**3070-75-S**

# **S E R V I C E N O T E**

## Agilent 3070 Board Test Systems

### OPERATIONAL SAFETY HAZARD

**Fig 1**

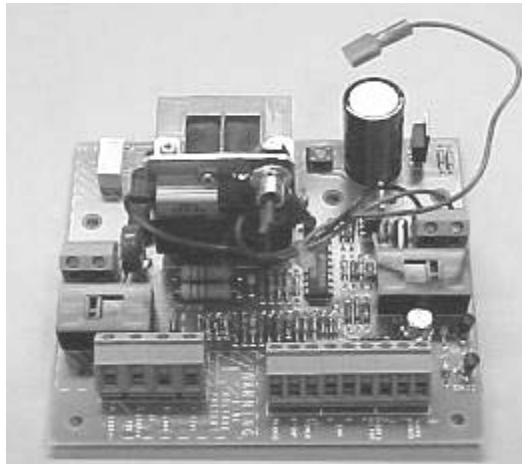
Investigations revealed that the DC voltage supplied to the 0490-2318 from the E1135-66501 control board was higher than specified as there was no voltage regulation. Over time, excess heat can damage the coil of the magnetic contactor which leads to the described safety hazard.

The solution is to replace the E1135-66501 control board in the PDU with a newer version (Fig 1) that incorporates a voltage regulator to the magnetic contactor.

**Fig 7**

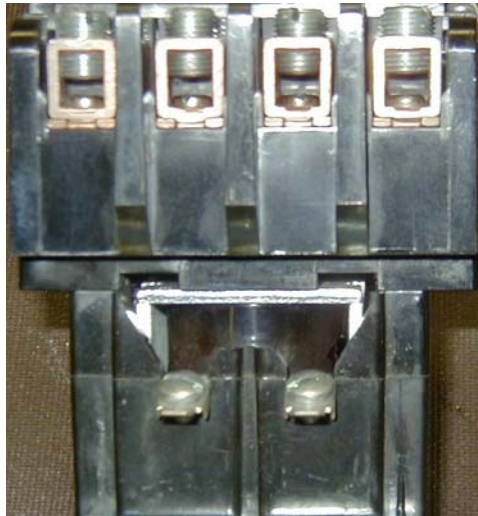
8. After opening the PDU. Inspect the contactor housing for cracks and “white” powdery type material (Fig 8). If the contactor has been or is suspected to be damaged, the entire PDU must be replaced by following the PDU Replacement procedure. If the contactor is good (Fig 7) continue with step 9.

**Fig 9**

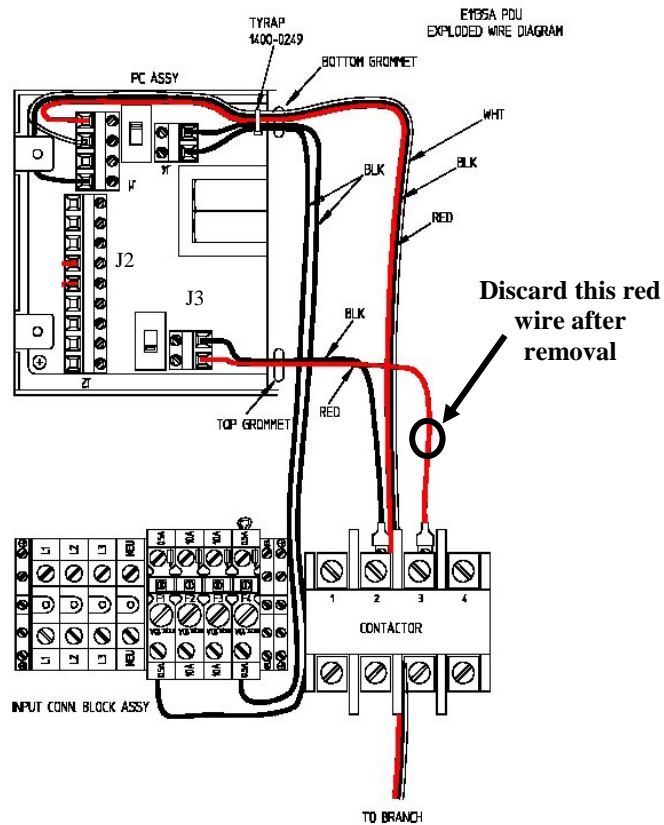
9. Remove the wires from the control board by using a small flat blade screwdriver. (Fig 9)
10. Make note of wire connections to J2 of control board.
11. Discard the red wire that was connected between “Contactor pin 3” and “J3 pin 1 control board”.

**Fig 10**

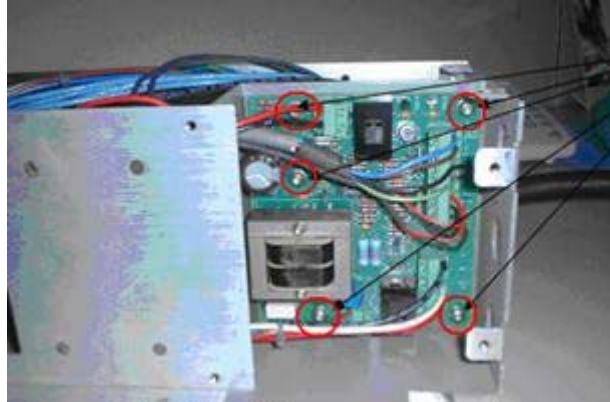
12. Remove the five M4 Torx screws holding the E1135-66501 control board to the PDU using a T20 Torx driver. (Fig 10)

**Fig 11**

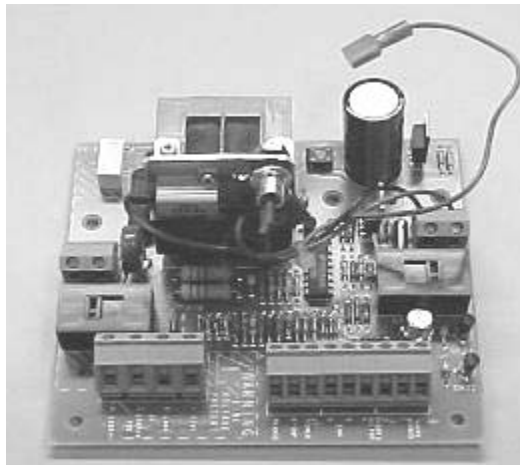
13. Remove the old control board from the PDU and discard.
14. Install the new control board (Fig 11) into the PDU using the five M4 Torx screws removed in step 12. Tighten these screws using a T20 Torx driver and torque to 16 inch-lb (1.81 n-meter)

Fig 12

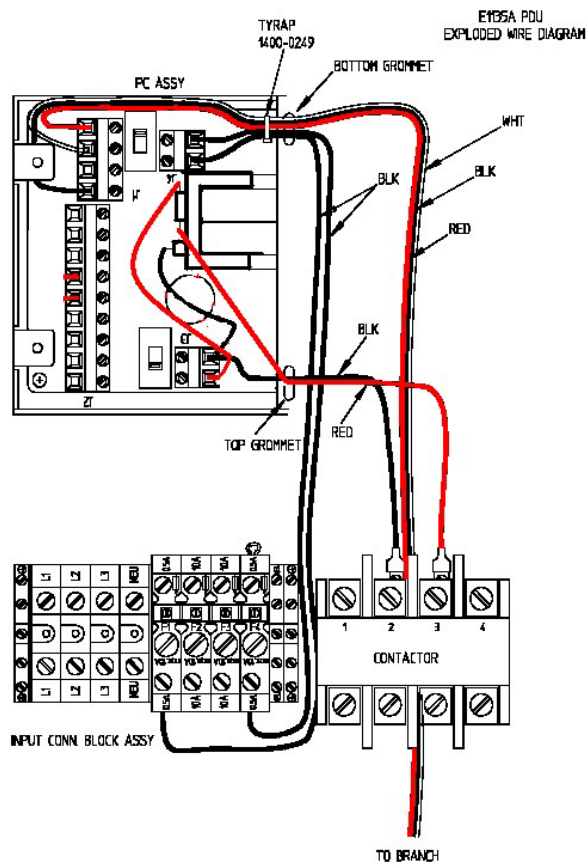
- Re-wire the control board using the wiring diagram in Figure 12 and wires removed from J2 on the control board in step 10.

Control Board to Contactor Connections		
Black Wire Contactor Pin 2	to	Control Board J3 pin 2
Black Wire Control Board J3 pin 2	to	Regulator on Control Board
Red Wire Contactor Pin 3	to	Regulator on Control Board
Red Wire Control Board J3 pin 1	to	Regulator on Control Board

**Note:** Wires from Regulator to J3 on control board are already connected when received from SPD.

**Fig 13**

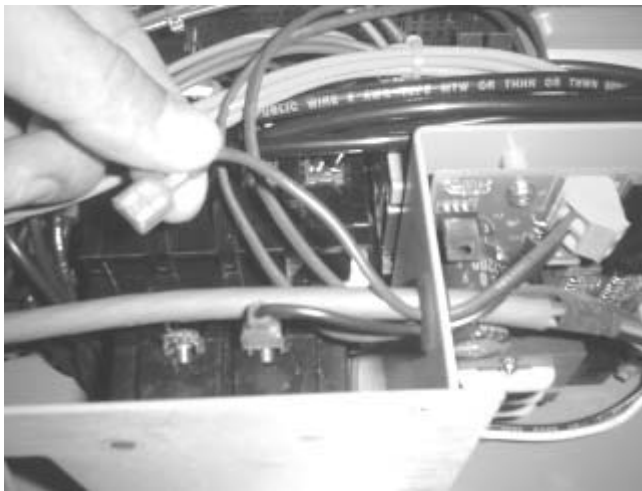
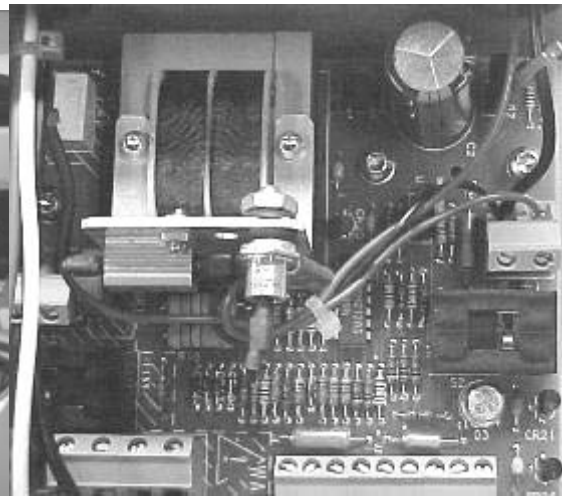
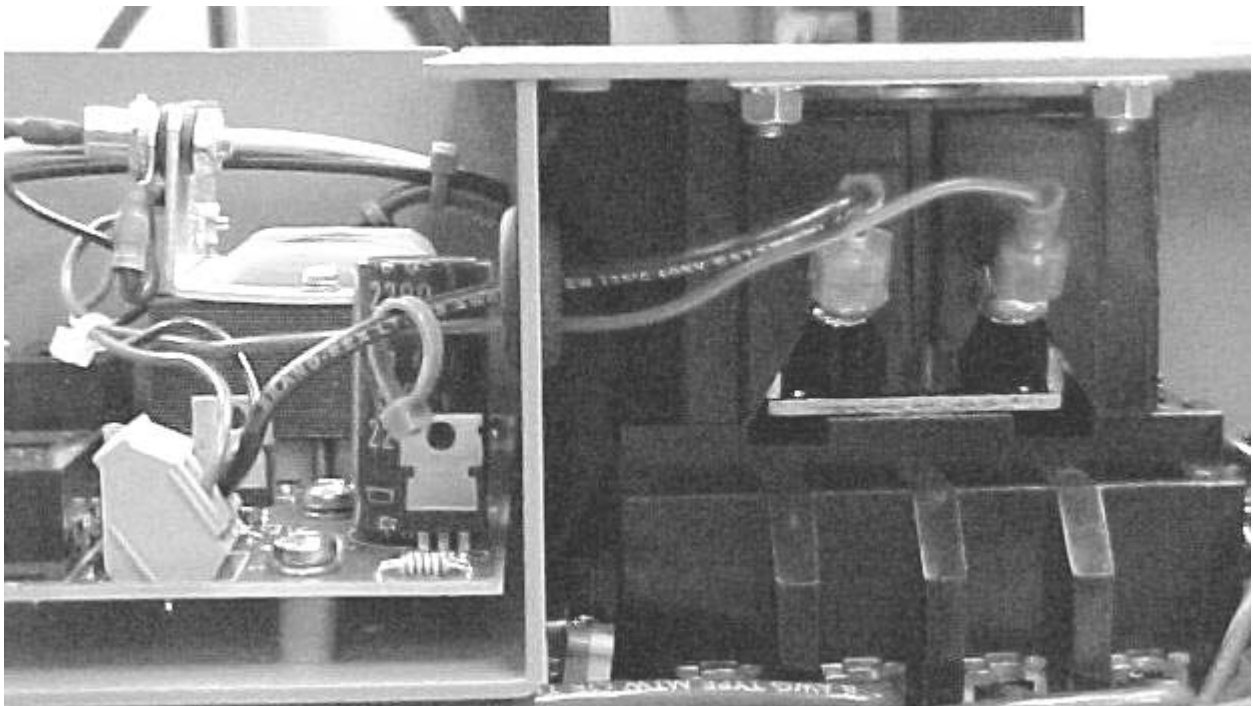
16. Figures 13, 14 and 15 show the new control board wiring.
